**North Rockland High School Projects – Phase 2**

**MSA File No. 43045**

**NOTICE TO BIDDERS**

Re: **ADDENDUM NO. 1**

ELECTRICAL HOCKEY FIELD INSTALLATION PLAN	Drawing No. <b>CE-103</b>
---	------------------------------

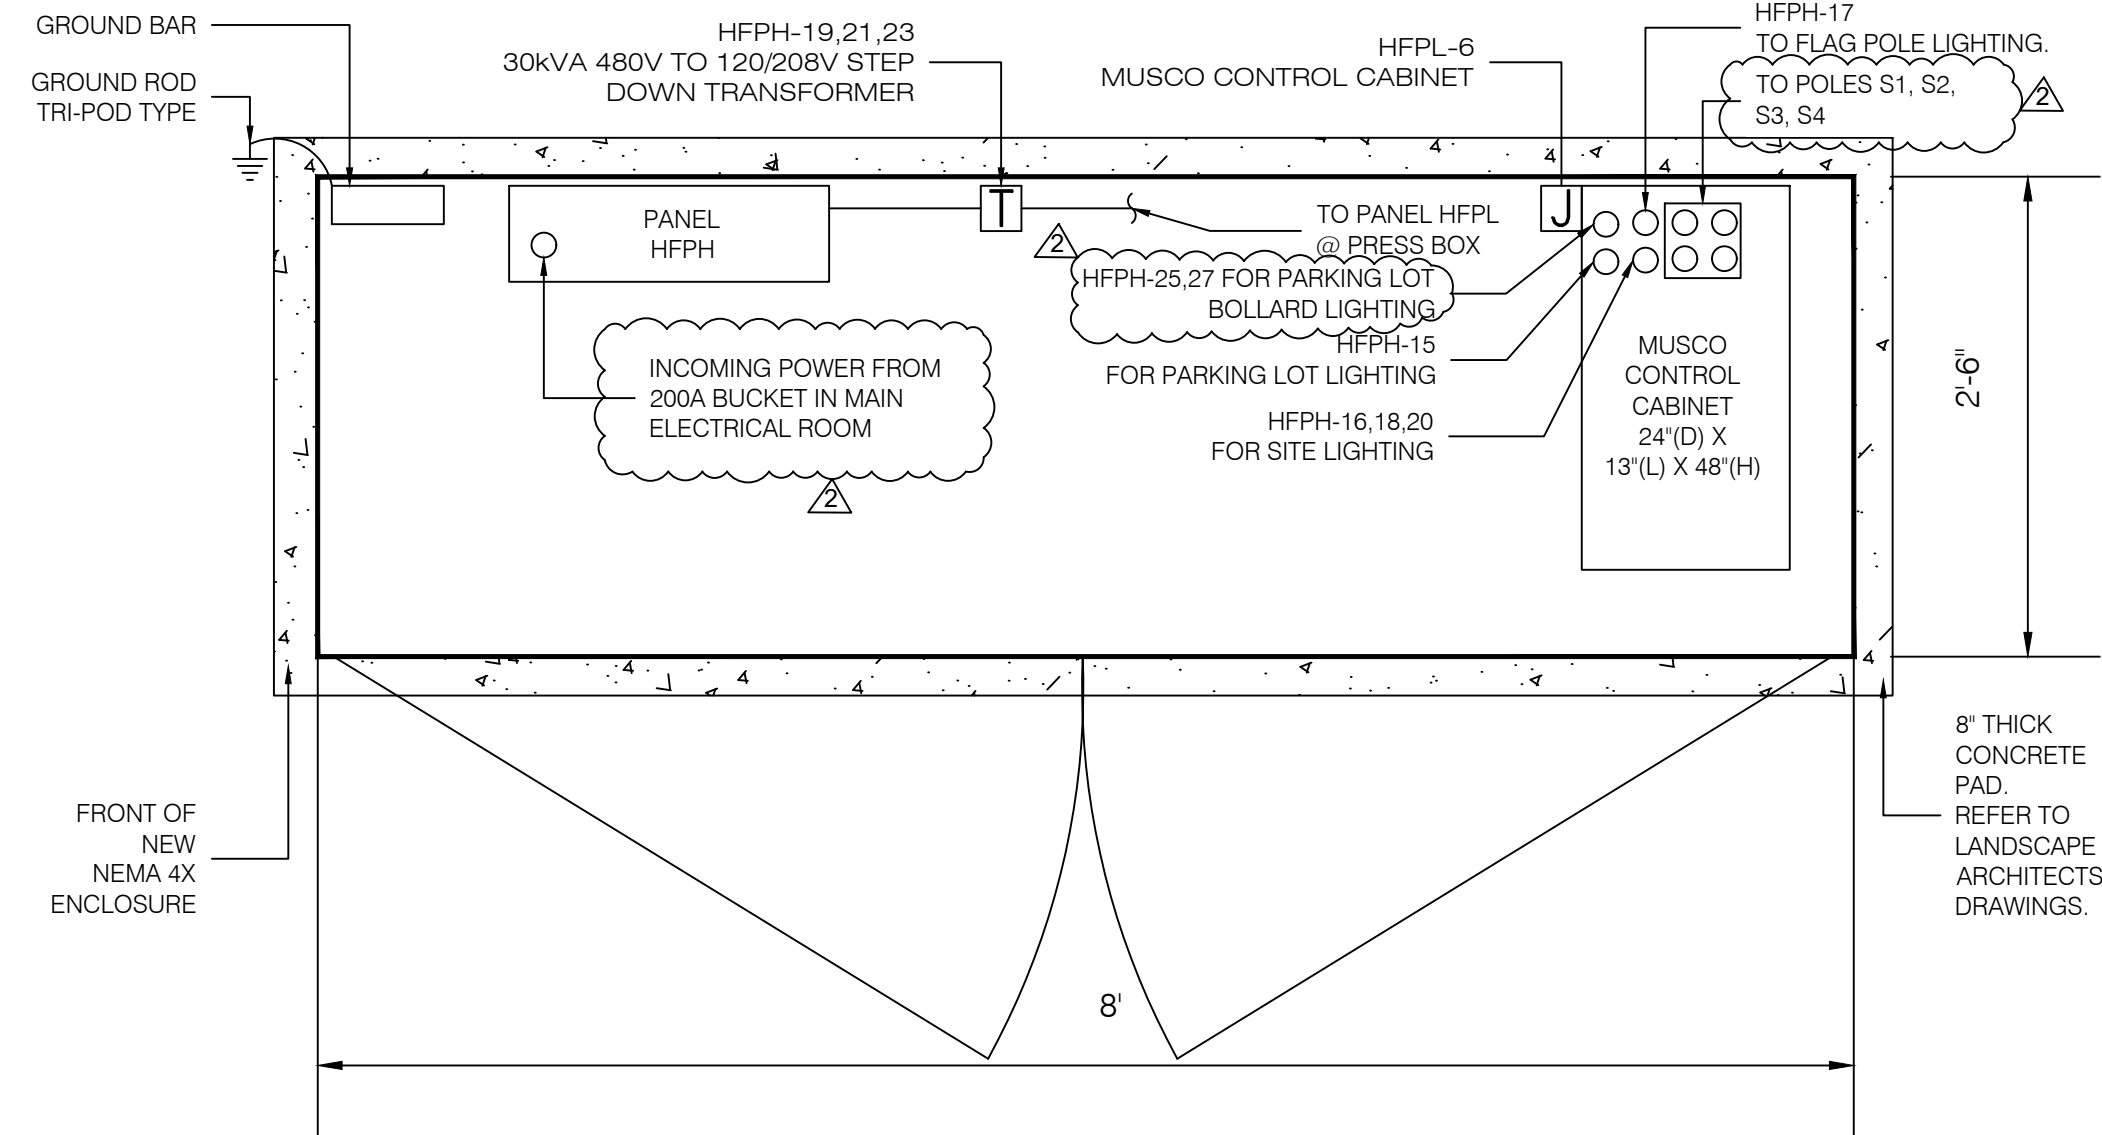
11) See attached revised drawings CE-102, CE-103, CE-501, CE-502, CE-503, CE-504 and CE-505 for updated sound system, controls and grounding detail.

Drawing No.  
**CE-104**

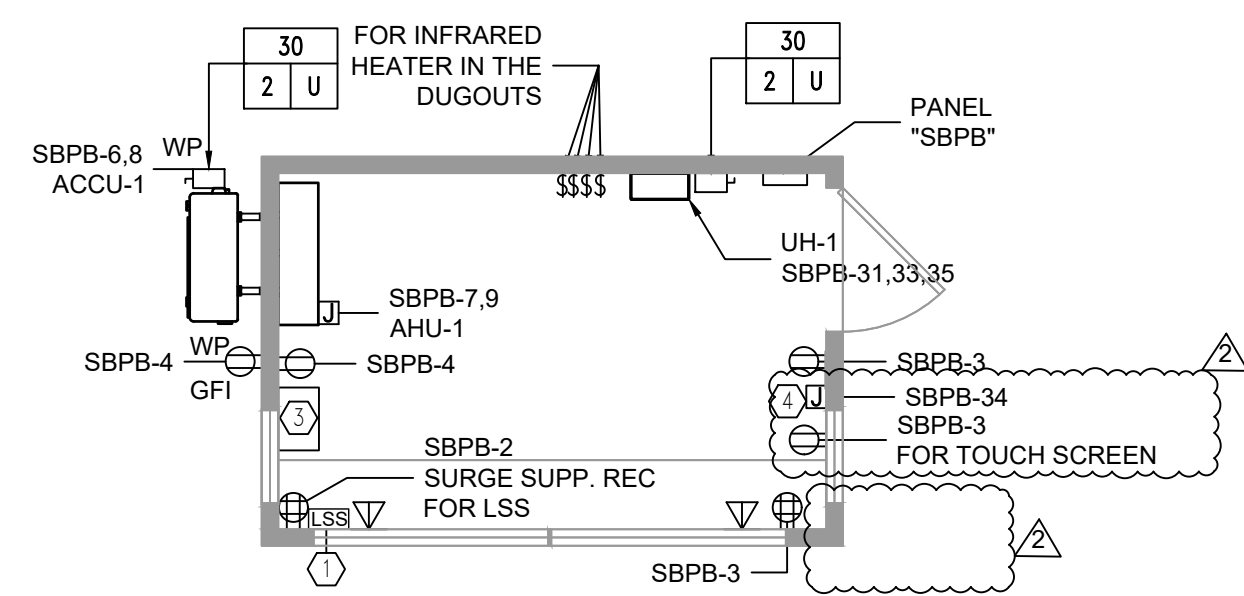
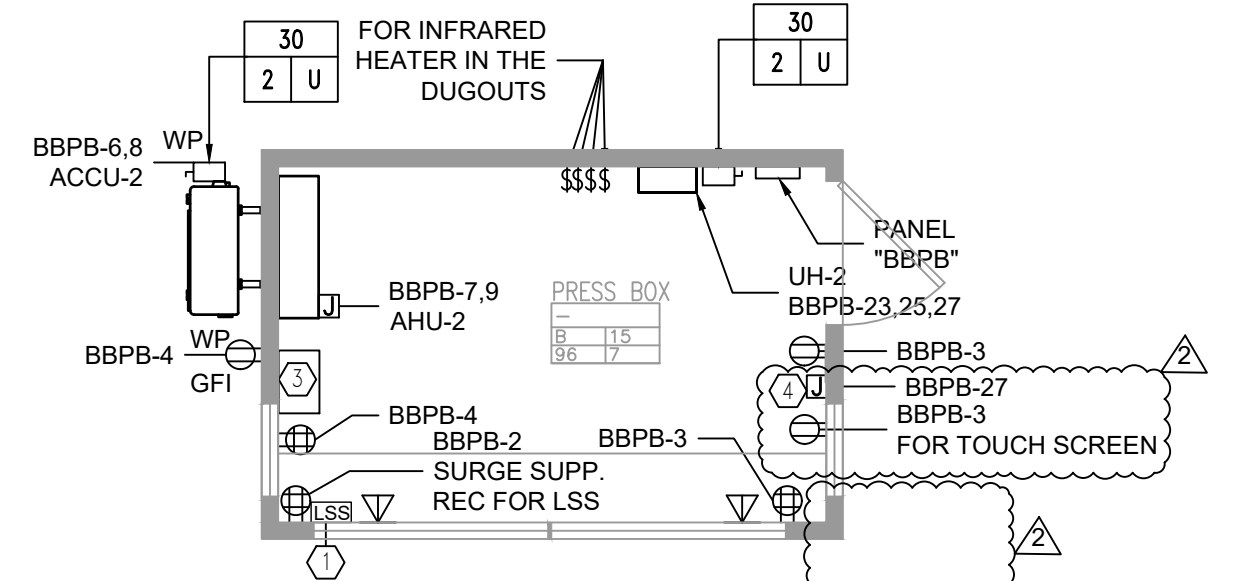
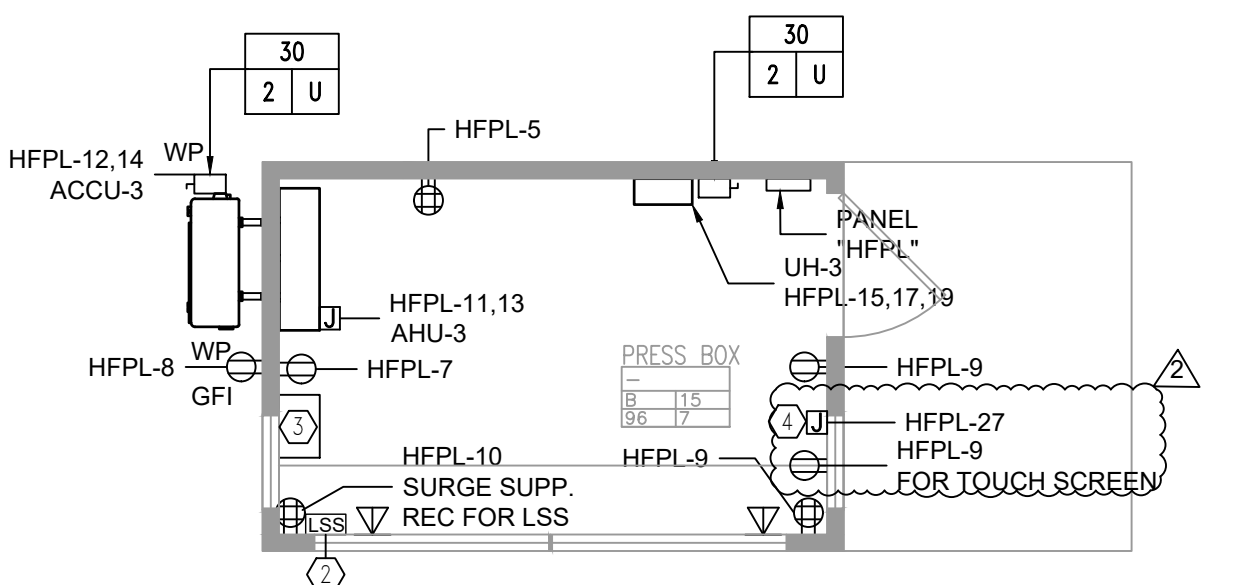
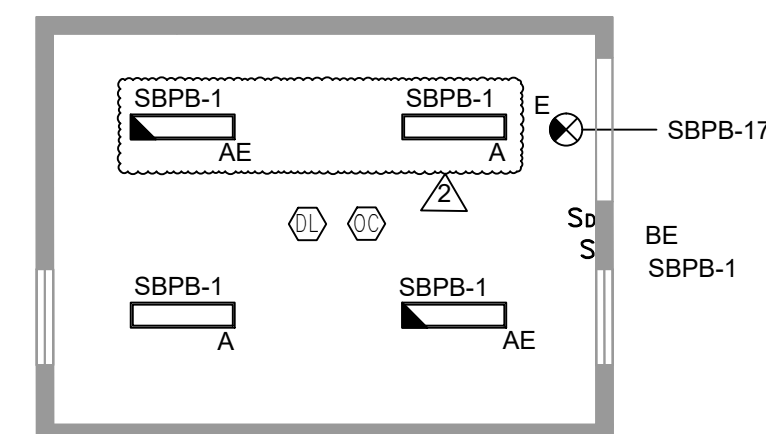
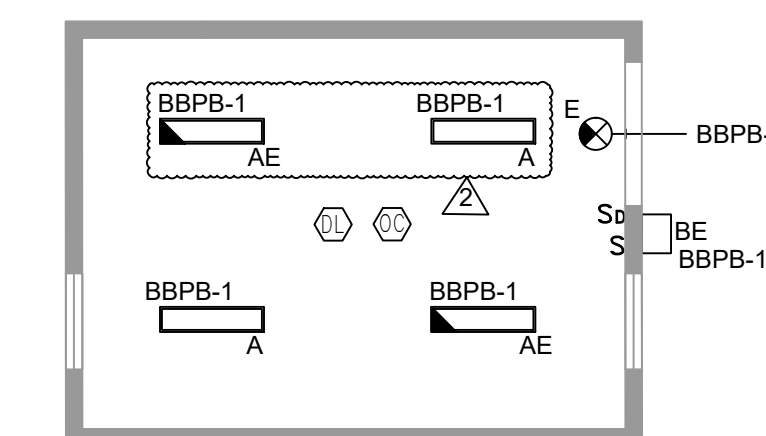
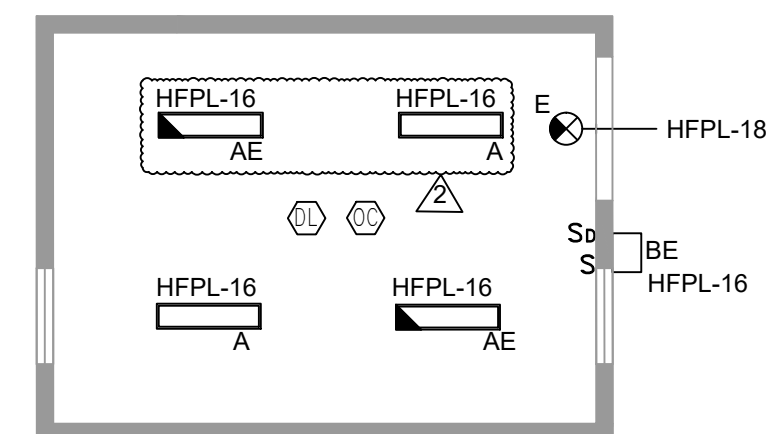
12) See attached revised drawing CE-104. The lighting layout has been revised to coordinate with drawing A-440. The lighting in the Dugouts are 1X4 abuse resistant fixtures.
